DR97-137 - PROPOSED COMFORT SUITES HOTEL BUILDING

REQUEST: Design Review of a proposed 3 story, 49 room hotel.

LOCATION: 226 Jibboom Street, south of Richards Blvd
001-0012-015
Richards Boulevard SPD, American River Parkway Corridor
Council District 3

SITE PLAN
SCALE: 1"=25'-0"

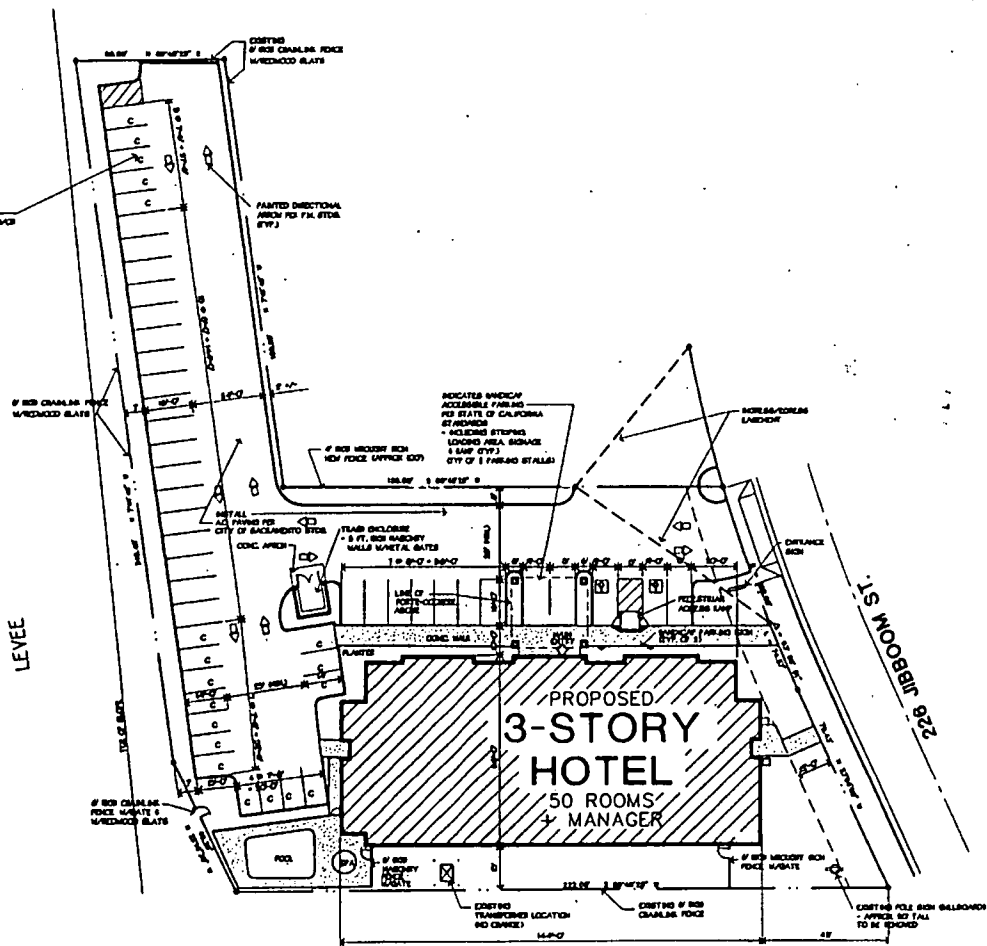
1. The proposed building is sited 12'-0" away from the property line along Jibboom Street. Because of the irregular shape of the lot, the building is placed sideways on the lot. The secondary entry facing Jibboom should have a larger decorative walkway leading to the street for greater emphasis.

2. Trees should be planted to flank the Jibboom Street entry area. Flowering shrubs and colorful plantings should also be utilized to add color and focus to the entry.

4. Wrought iron is proposed for fencing in areas visible from the street. Chain link fencing is proposed at rear property line and along other property lines not visible from street view. Staff recommends that if chain link fencing is proposed, it should be dark green plastic coated and planted with vines.

6. An existing 30'-0" high pole sign is being removed by the applicant. New signage is proposed on the building facades. Staff supports the proposed signage in lieu of the less appealing pole sign. A monument sign is proposed at the driveway entrance from Jibboom Street. The sign should reflect the architectural character, colors, and materials of the proposed building. Staff recommends that the sign be no taller than 5'-0" high. Detailed information on the monument sign should be provided for review by the Board when the project returns for final Board action.

**CONCEPTUAL
LANDSCAPE
SITE PLAN**
SCALE 1" = 20'-0"

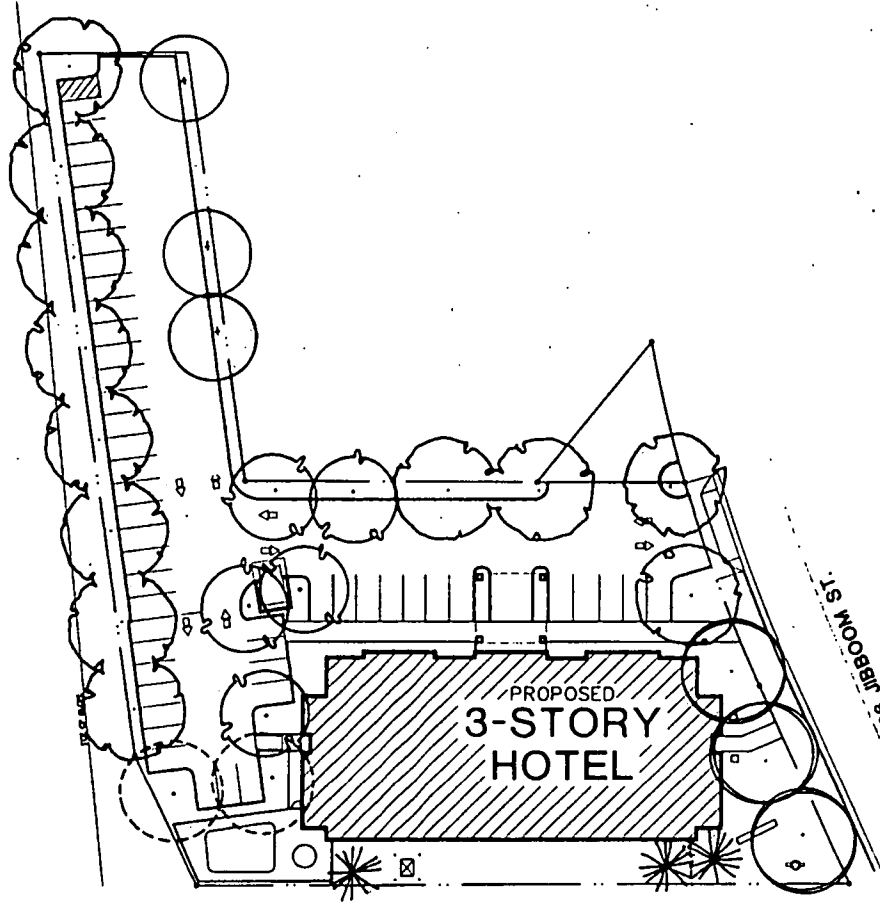
3. A more detailed landscaping and irrigation plan shall be provided to the Board when the project is returned for final action by the Board. Provide details on all proposed hardscape on the site.

EXTERIOR ELEVATIONS

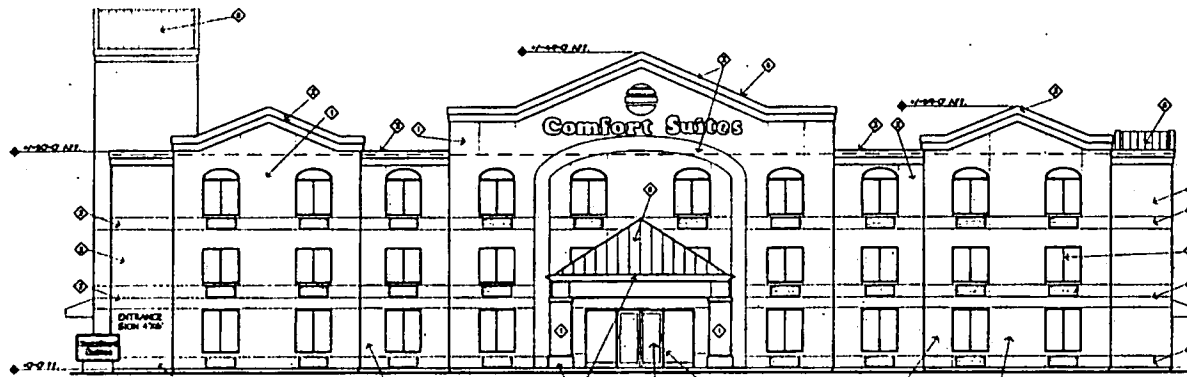
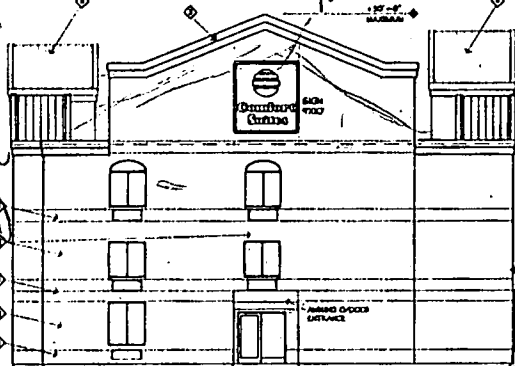
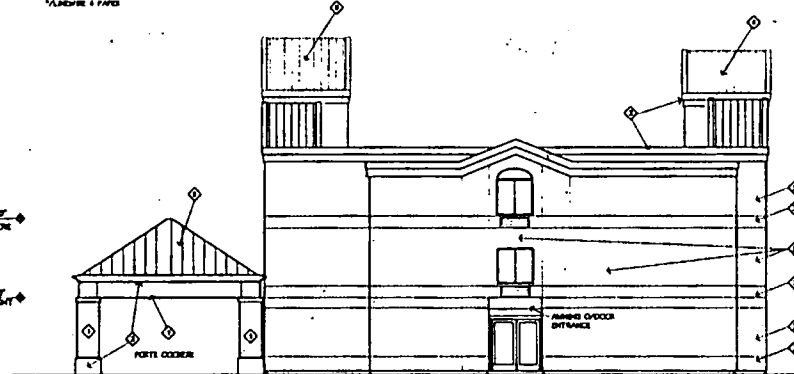
12. A portecocher with a hipped metal roof is proposed at the main entry on the north elevation. Staff recommends that a smaller version of the portecocher entry, with more understated columns, be placed over the secondary entry doors on the Jibboom Street elevation (east). This will add dimension to the east elevation and create a focal point on the streetscape.

13. The proposed window system is repetitive because of the building's use, and lacks visual interest. Staff recommended a single or double hung window, but the applicant informed staff that they are not safe for hotels. If that is the case, staff recommends that the windows have a wide frame, possibly with grids for additional visual interest, and that a sill element be provided.

- 14. Proposed grilles for AC system indicated on the plans shall be flush mounted in the wall and painted to match the plaster, to minimize their visibility.
- 15. Mechanical equipment shall be adequately screened behind the proposed parapet walls.

Shadow lines
Symmetry
Small changes
over door
Choice of window system
Access numbers

not of character

NORTH ELEVATION
LOOKING SOUTH

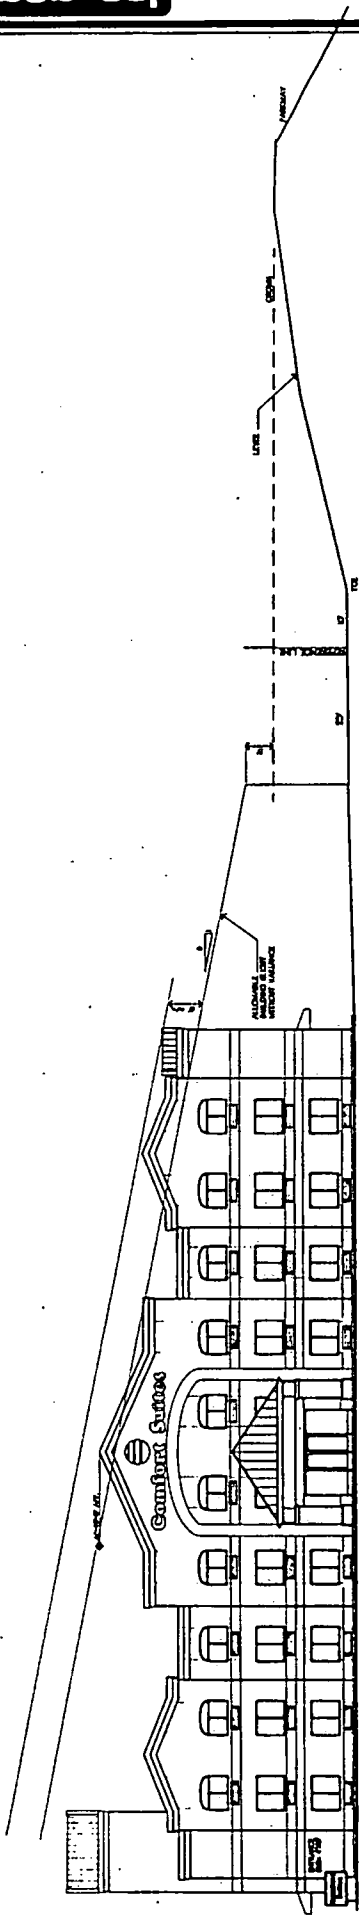
Curved sign

Reduction in ht of gable

raise monument sign

Street deserves front not a service entrance.
monument structure - smooth as possible
